## Fields at Sherborn: Site Redesign and Nitrogen Loading Issues

Submitted by Neil Kessler

December 17, 2015

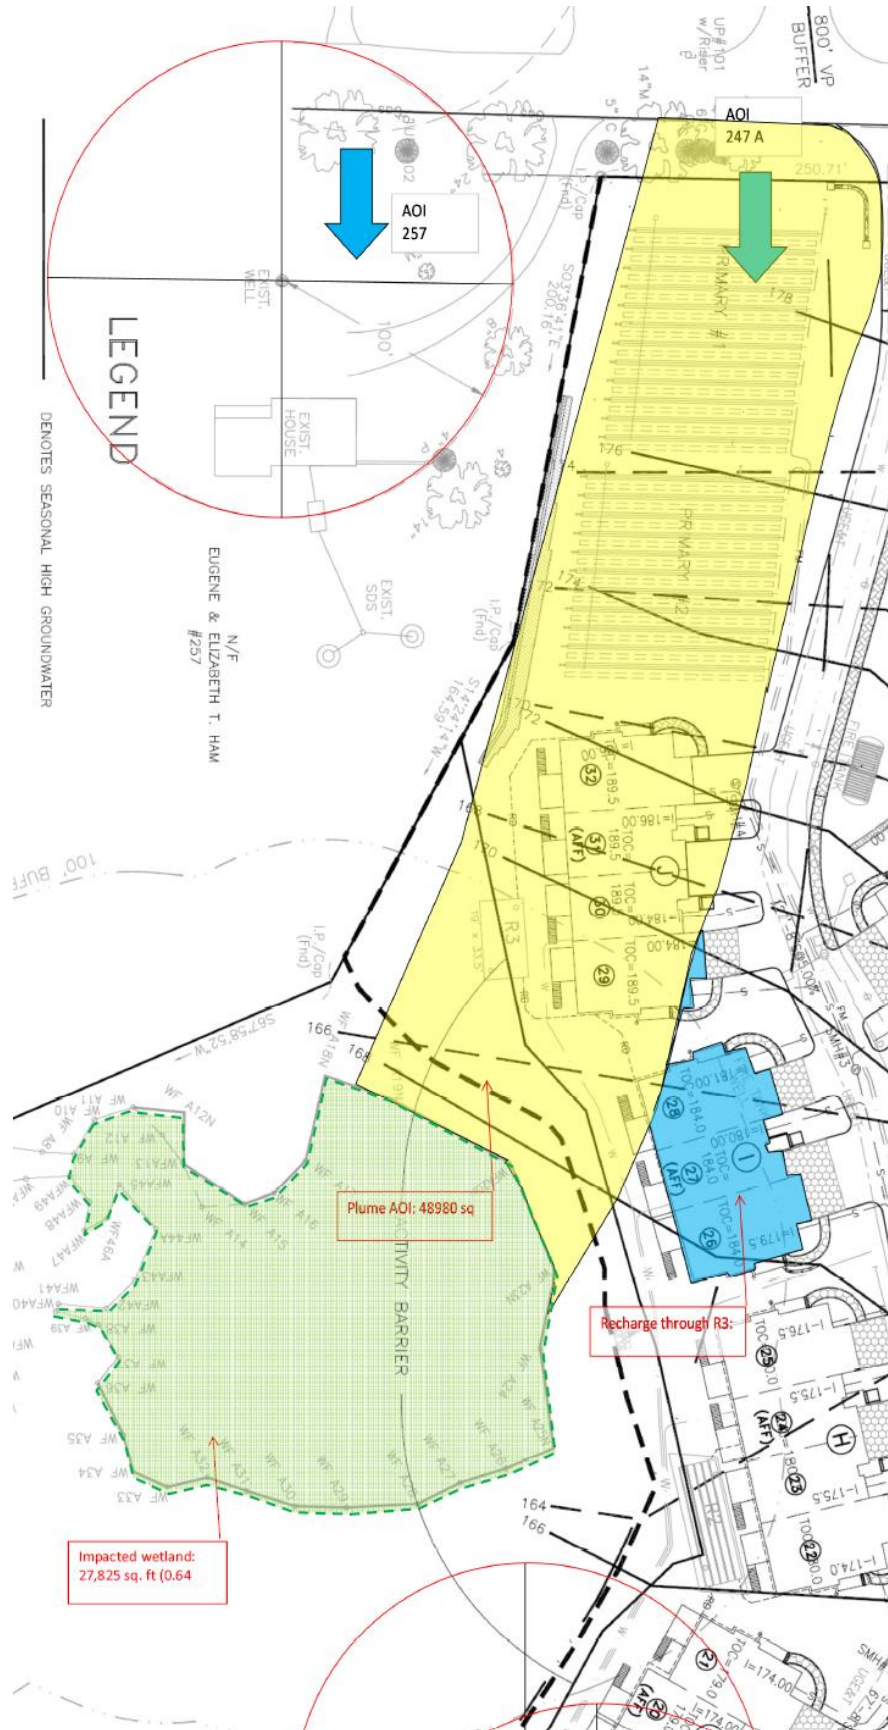
- If one can conclude that there is an impact to the adjacent wetland, it's relevant to ask whether some portion of those wetlands lie within the Zone II wellhead protection area discussed in previous hearings (see Appendix B).

- While the wells have been moved out of the septic plume's direct path, given the potentially dramatic levels of nitrogen loading, wells adjacent to these wetlands may still suffer from nitrogen contamination when the overloaded wetland begins leaching nitrogen that it cannot either uptake vegetatively or denitrify.
